**AGENDA
PLANNING COMMISSION REGULAR MEETING
CITY OF FARMINGTON HILLS
SEPTEMBER 23, 2021, 7:30 P.M.**

Lot Split Review

Site Plan Review

Site Plan Review

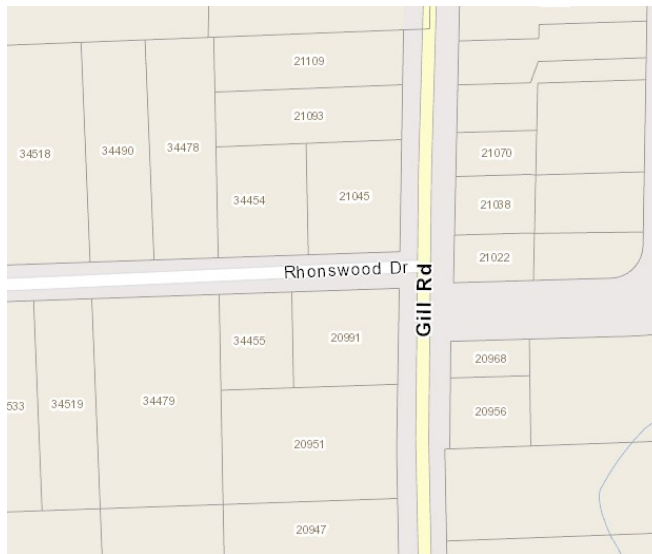
b. Any partition or division shall be of such location, size and character that, in general, it will be compatible with the existing development in the area in which it is situated. *The parcels will both have frontage on Fendt, and one will also front on Gill. Parcels in this area have a fairly wide variety of sizes, proportions, and widths. The immediately abutting parcel to the south is approximately the same size as the existing parcel; the split will create a rear-to-side relationship between the parcel to the south and Parcel 2. This is not common in the neighborhood, but is similar to the arrangement of lots one block north at Gill and Rhonswood (see graphic).*

SITE PLAN NEW LEASING BUILDING

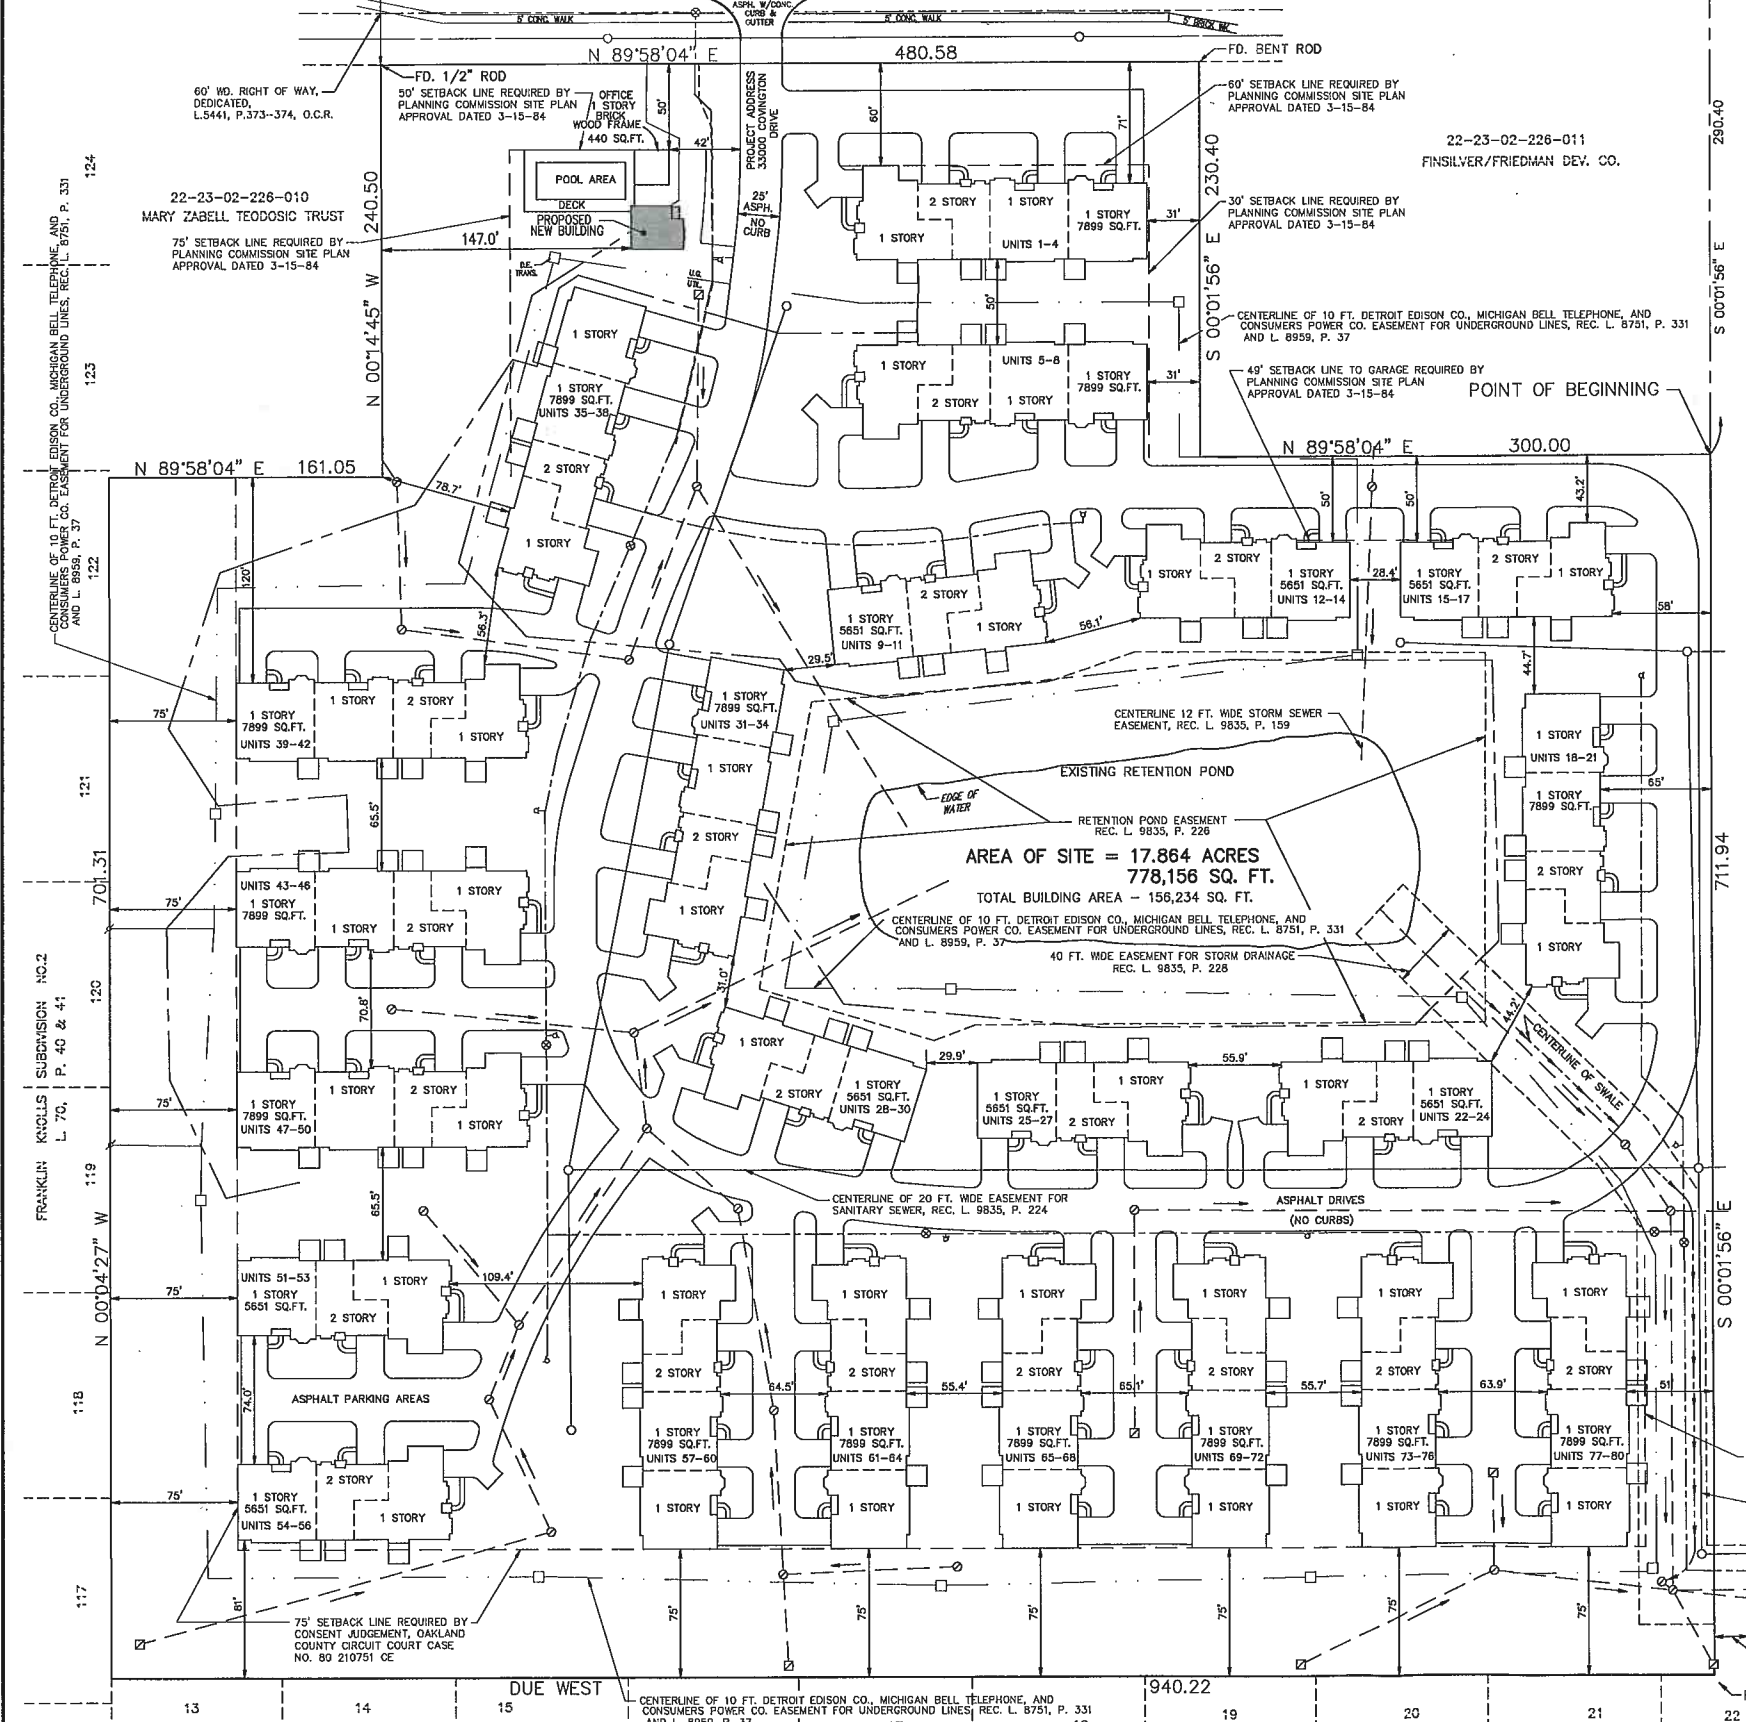
3. **Dumpster (34-5.1.2.D).** No dumpster is proposed.
4. **Mechanical Equipment (34-5.1.4.D).** ground-mounted equipment is not noted on the plan; such equipment shall not be located on the Covington Club Drive side of the building.
5. **Minimum parking (34-5.2.11.D.iii).** Two (2) spaces are required for an office space of this size. The parking area appears to accommodate this. Five spaces, including one ADA-accessible space are provided.
6. **Off-street parking dimensions (34-5.3.3.A & B.).**

9. **Required Site Plan Elements.** The zoning of the subject and surrounding properties should be noted on the site plan.
10. **Lighting (Section 34-5.16).** It appears that the only lighting proposed is six sconces: two on the existing pool building, two on the new building, and two at the new gate in the low wall. **Cut sheets of the fixtures should be provided to confirm that these meet the cut-off standard of the ordinance.**

1. The overall Covington Place Apartments were built in the mid-1980's. For this expansion, the proponent will be obligated to confirm that the detention system including the pump that is used for discharge is operating per the original approved plan.

1. Please provide the existing retention volume and confirm that the storm drainage pump is functioning as was approved and intended.

PROPOSED SITE PLAN

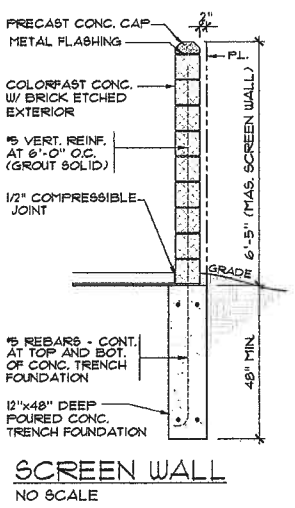
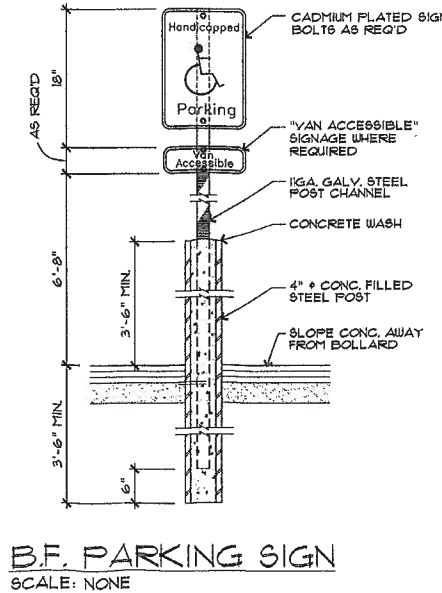
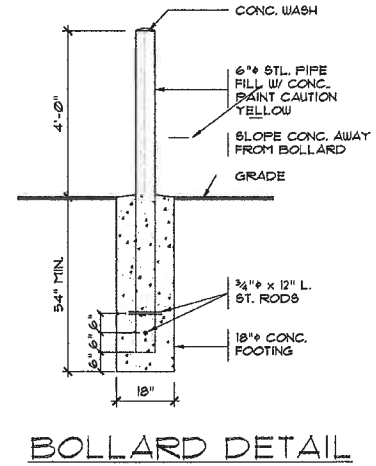
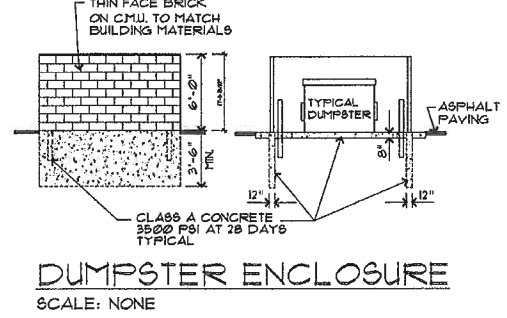
Item	Required	Proposed/Comments
Maneuvering lane width	20 ft.	19.9 ft at narrowest; the sidewalk here should be adjusted to provide the full 20 feet.
Parking space width	9 ft.	9 ft.
Parking space length	20 ft. for minimum required (May include a maximum two-foot unobstructed vehicle overhang area at the front of the parking space.) 17 ft. for additional parking (May include a maximum one-foot unobstructed vehicle overhang area at the front of the parking space)	20 ft/18 ft w/ overhang

11. **Building.** The façades of both buildings are proposed to be redone, with a thin face brick over the existing CMU.
12. **Corner Clearance (34-5.10).** No change to the existing. **Corner clearance triangles should be indicated on the plan, though it appears that the driveway is compliant.**

1. The plan has a limited amount of topo with very little information being provided on the utilities in the area. Although grades may have been provided, it is difficult to identify the sanitary sewer, the watermain and the storm sewer in the area as well as the appropriate structures that accommodate them. This needs to be addressed.

5. A 5-foot-wide sidewalk is required along the Shiawassee Road frontage of this site. The plans need to provide for this as part of their requirements. It's location should be one foot north of the ultimate right-of-way line. This will be reviewed by the Engineering Division during construction review.

6. Stormwater detention in the amount of 2 inches over the gross area of the site must be provided for. In addition, discharge must be restricted to an agricultural rate. The plans need to identify how this will be accommodated for this site.

10. Storm drainage must be addressed with a storm system that is provided for the parking lot. In addition, it must tap into an existing catch basin or storm inlet in the area. The plans needs to identify how this design will be accommodated.

11. The plans identify the removal of an existing fence along or near the west property line and installation of a 6-foot-high screening wall that appears to be approximately 5 feet off of the property line. We question why this wall is not being placed closer to the property line.

1. Existing site does not meet 50' turning radius requirement. Please contact the Fire Marshal to discuss Alternate Protection provisions outlined in Section 12-11(4).
2. Gates shall meet International Fire Code and Fire Prevention Ordinance requirements.
3. Please verify the site meets Chapter 12, Section 12-11(2) of the City Code. Plans are not of sufficient detail to make this determination.
4. Building shall be maintained in accordance with minimum Fire Prevention Code requirements.
